California Ridge Wind Farm Champaign County, IL

Natural Resource Report

October 6, 2011

California Ridge Wind Farm Natural Resource Report Summary

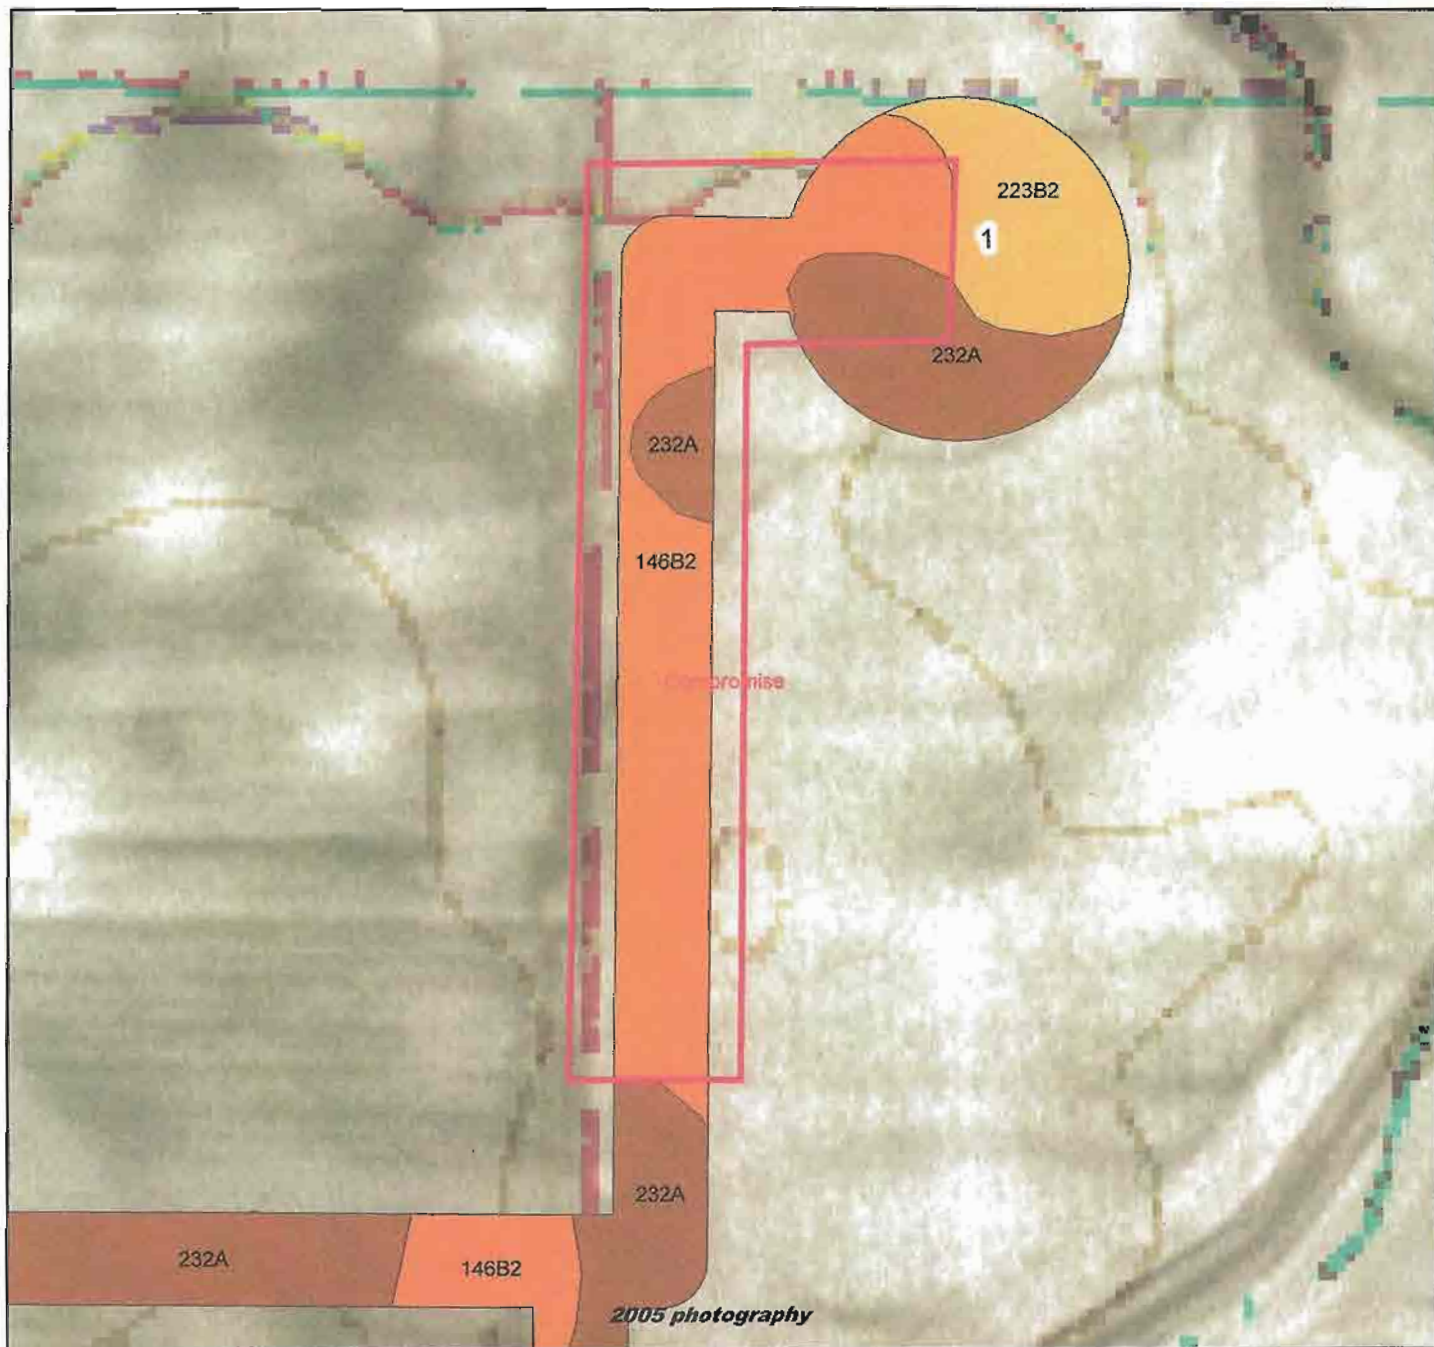
The 146B2 (Elliott Silty Clay Loam) soil has a 2-4% slope that could be an issue with water flowing over the access road possibly causing erosion of the road surface or depositing silt on the access road. The area most susceptible is outlined in a red rectangle.

The 223B2 (Varna Silt Loam) soil has a 2-4% slope and is located adjacent to the turbine and could present erosion issues during and after construction.

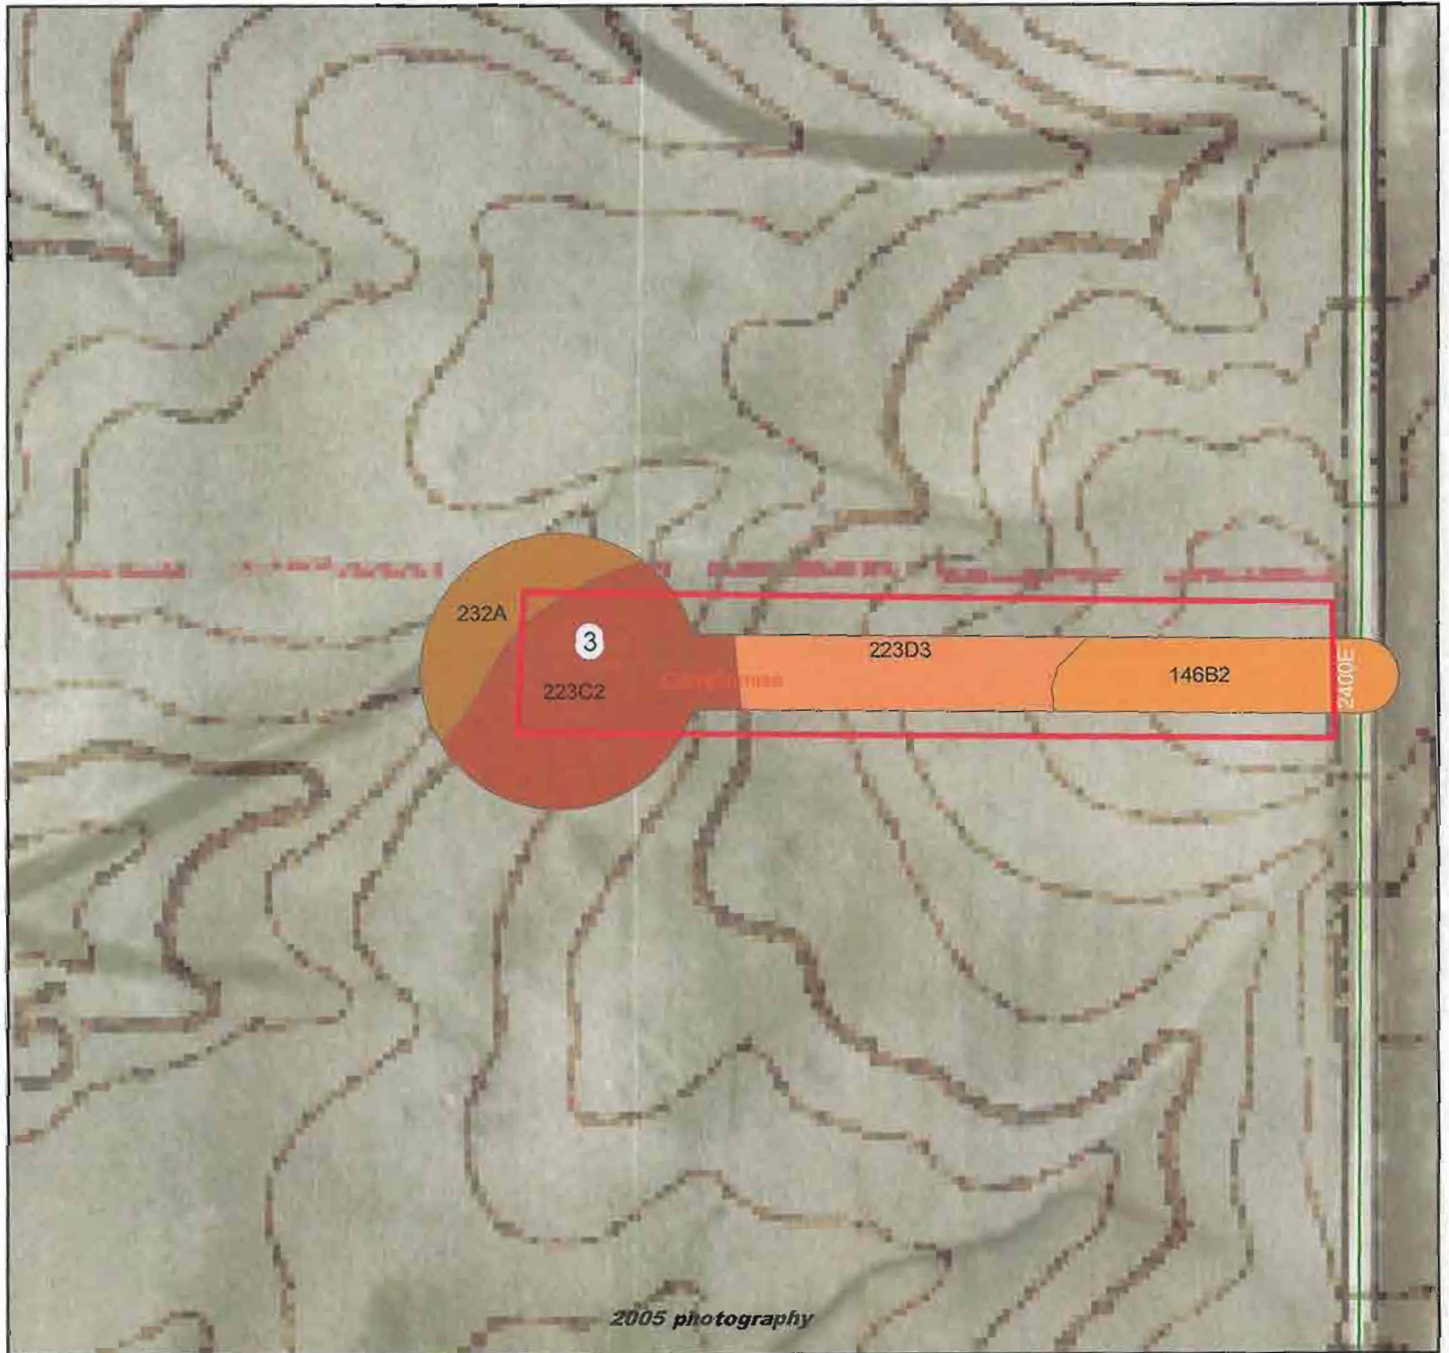
The 146B2 (Elliott Silty Clay Loam) soil has a 2-4% slope and 223C2 and 223D2 soils have a slopes of 2-6% that could cause erosion of the road surface or depositing silt on the access road and parking area. This site could also have erosion issues along the edge of the access road with gully erosion due to the orientation of the slope in relation to the road. The area most susceptible is outlined in a red rectangle.

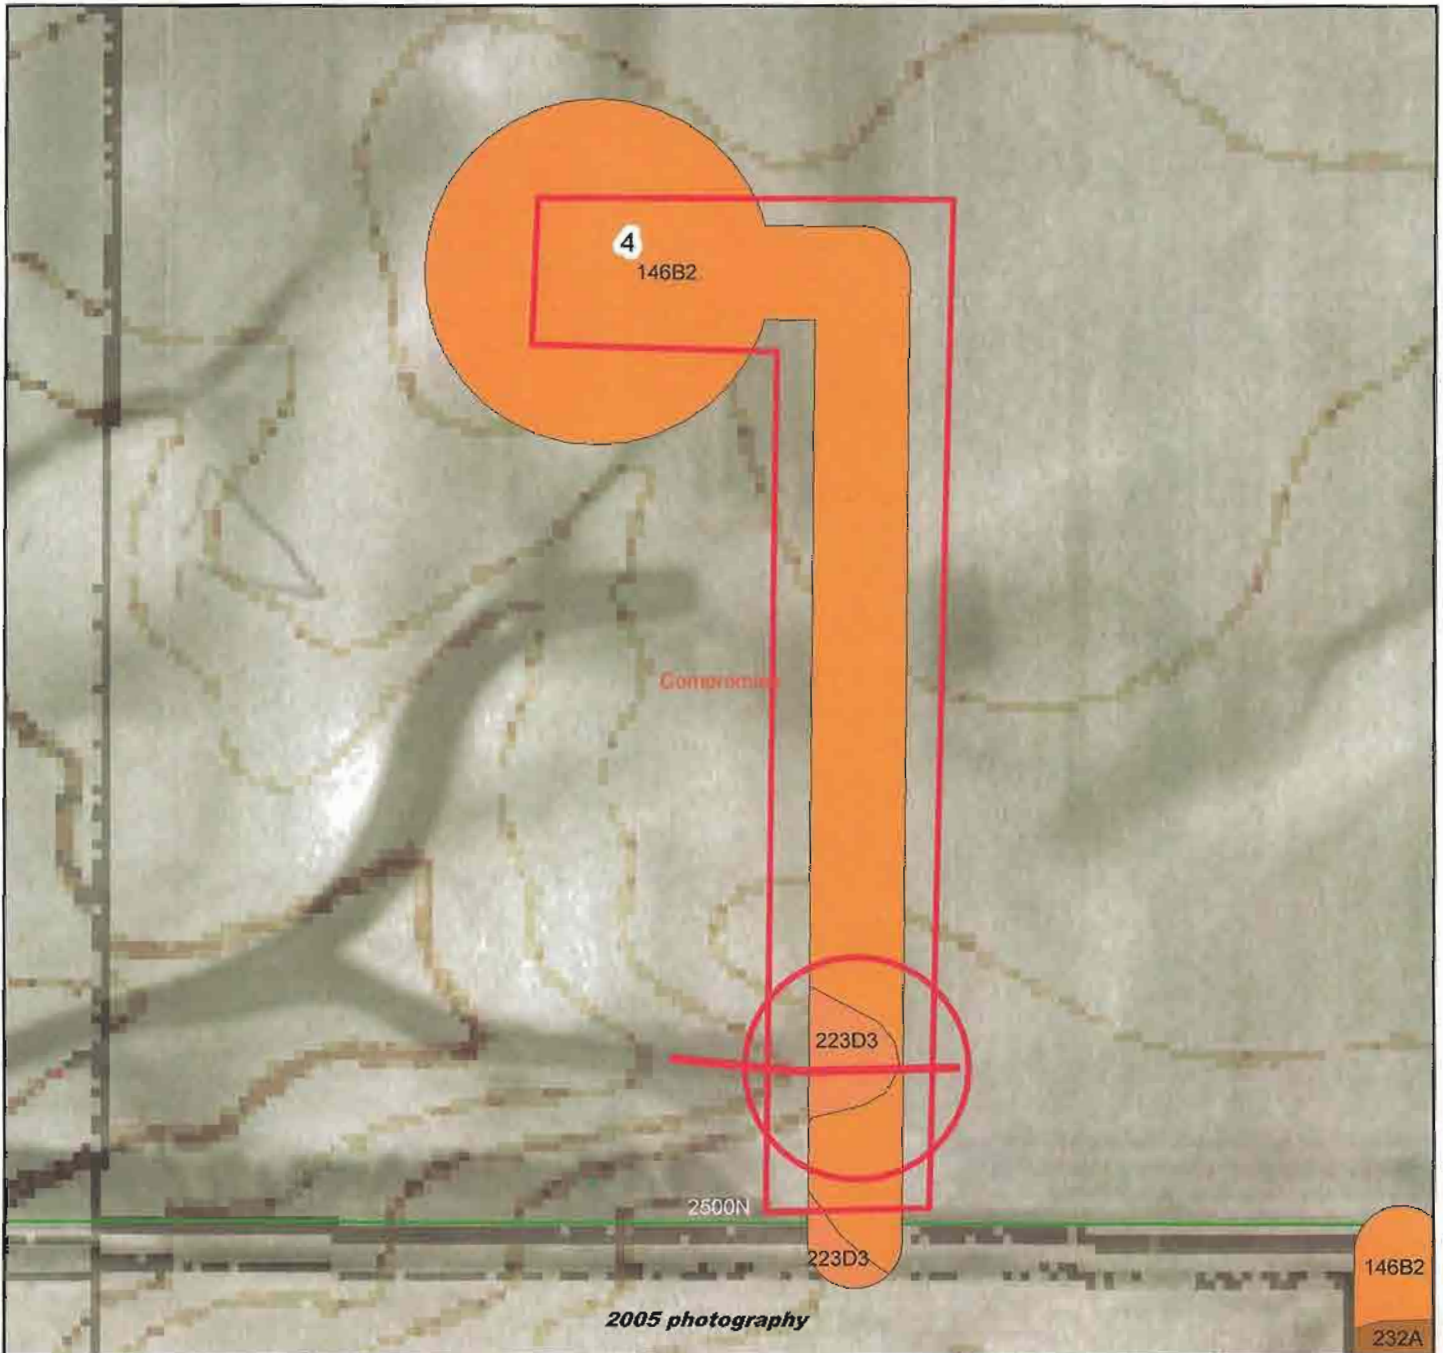
The 146B2 (Elliott Silty Clay Loam) soil has a 2-4% slope and 223D3 soil has significant slopes that could cause erosion of the road surface or depositing silt on the access road and parking area. The area most susceptible is outlined in a red rectangle.

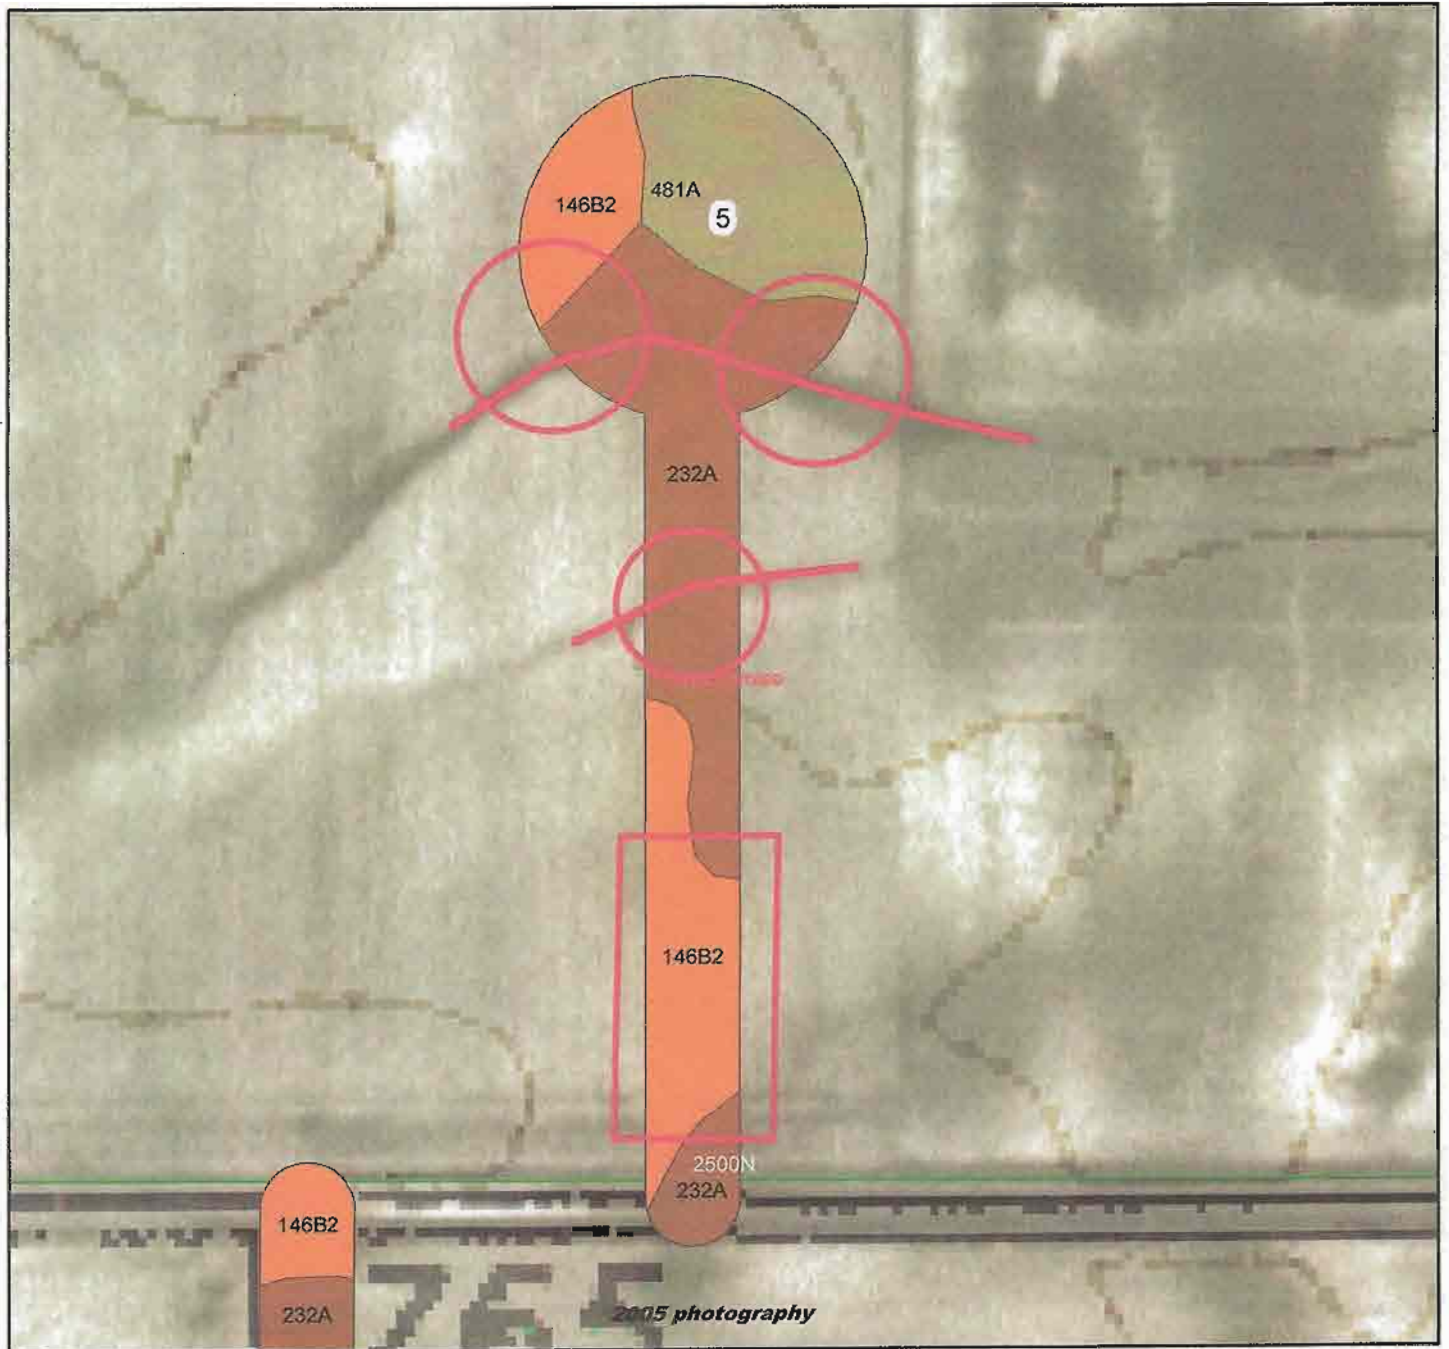
The 146B2 (Elliott Silty Clay Loam) soil has a 2-4% slope that could be an issue with water flowing over the access road possibly causing erosion of the road surface or depositing silt on the access road. The area most susceptible is outlined in a red rectangle.

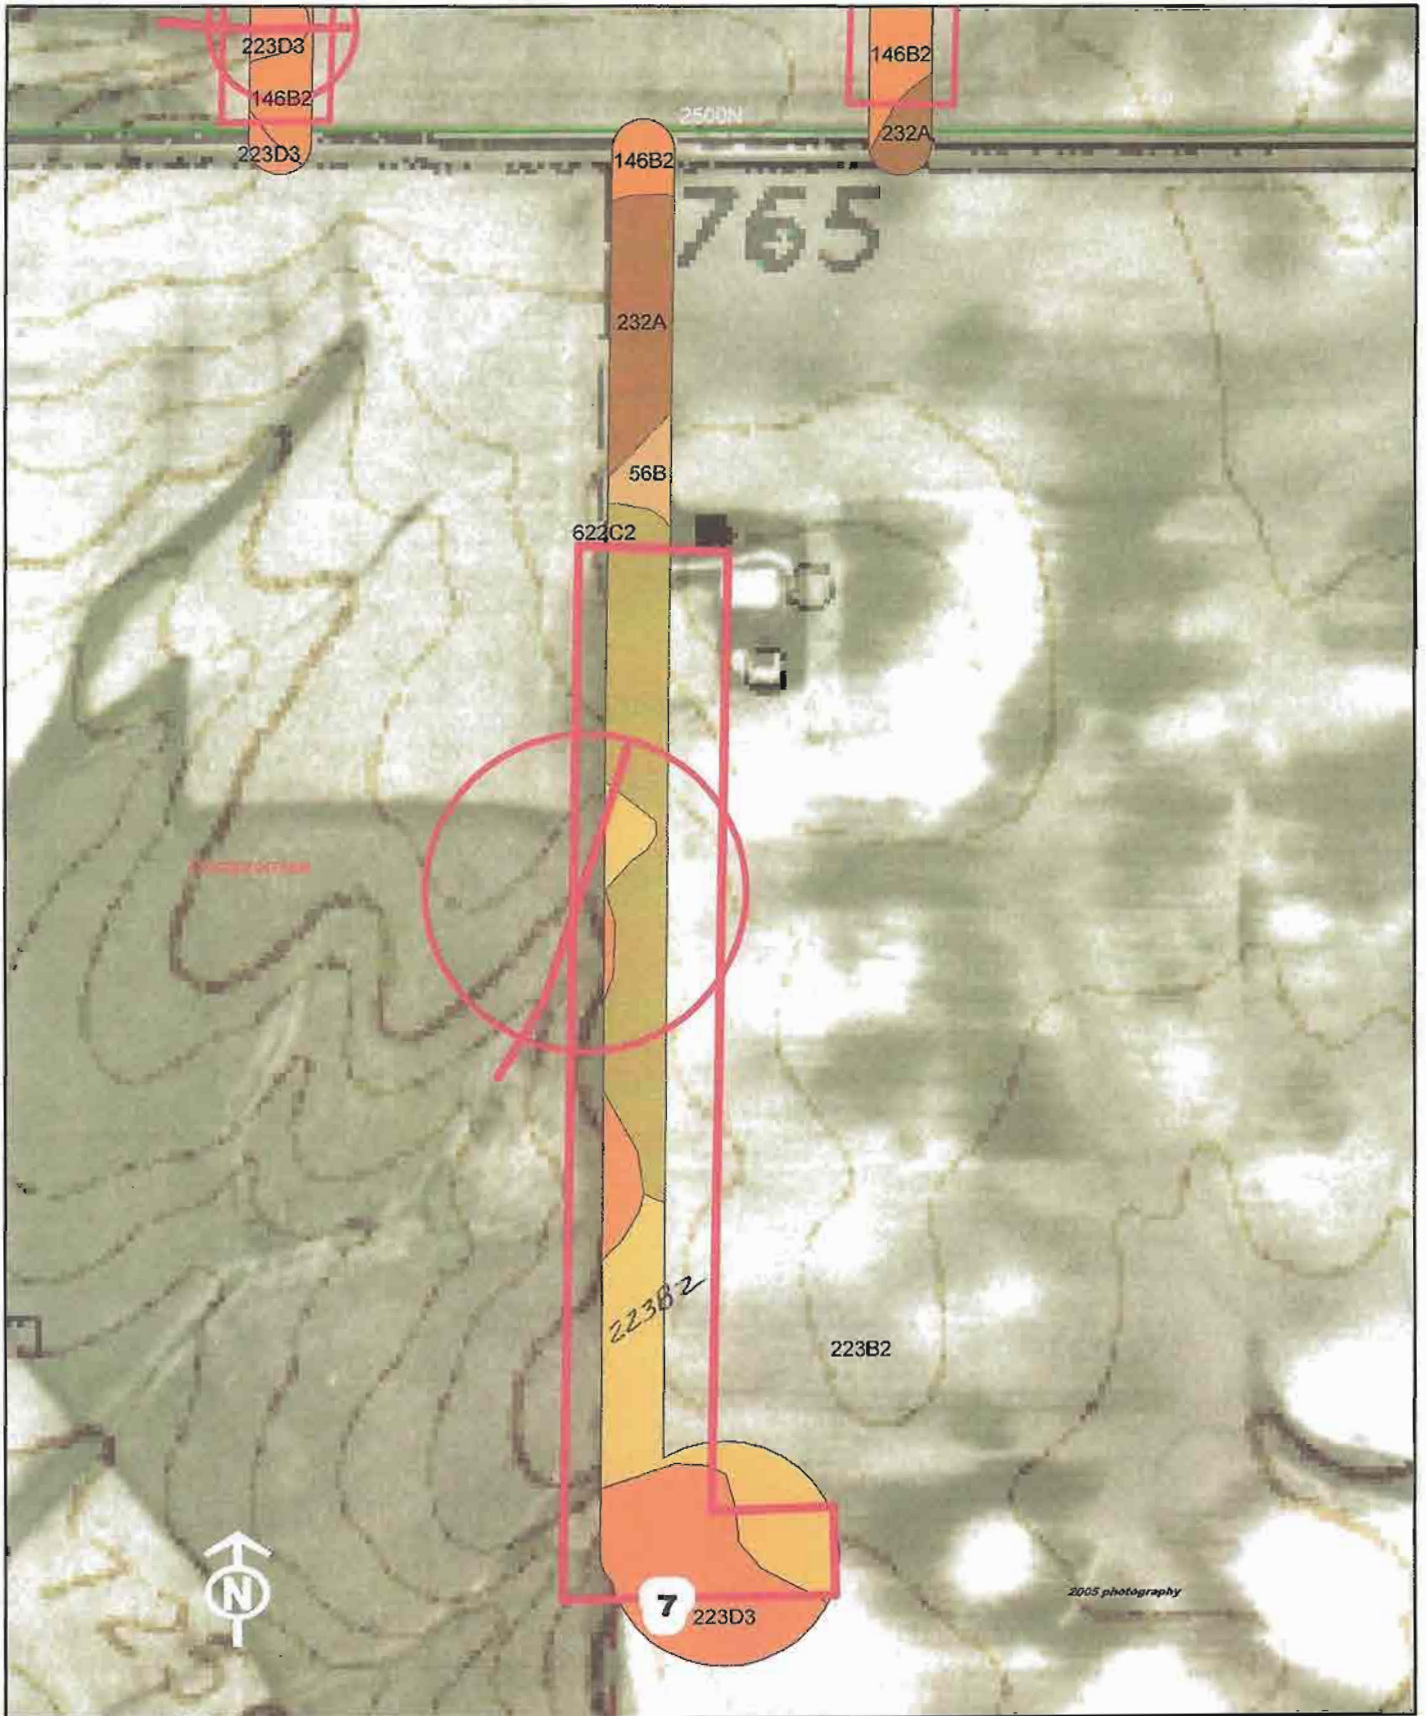
The 146B2 (Elliott Silty Clay Loam) soil has a 2-4% slope that could be an issue with water flowing over the access road possibly causing erosion of the road surface or depositing silt on the access road.

The 223B2 and 223D3 (Varna Silt Loam) soils have significant slopes to them that could be an issue with water flowing over the access road possibly causing erosion of the road surface or depositing silt on the access road and turbine parking area.

The area most susceptible is outlined in a red rectangle.
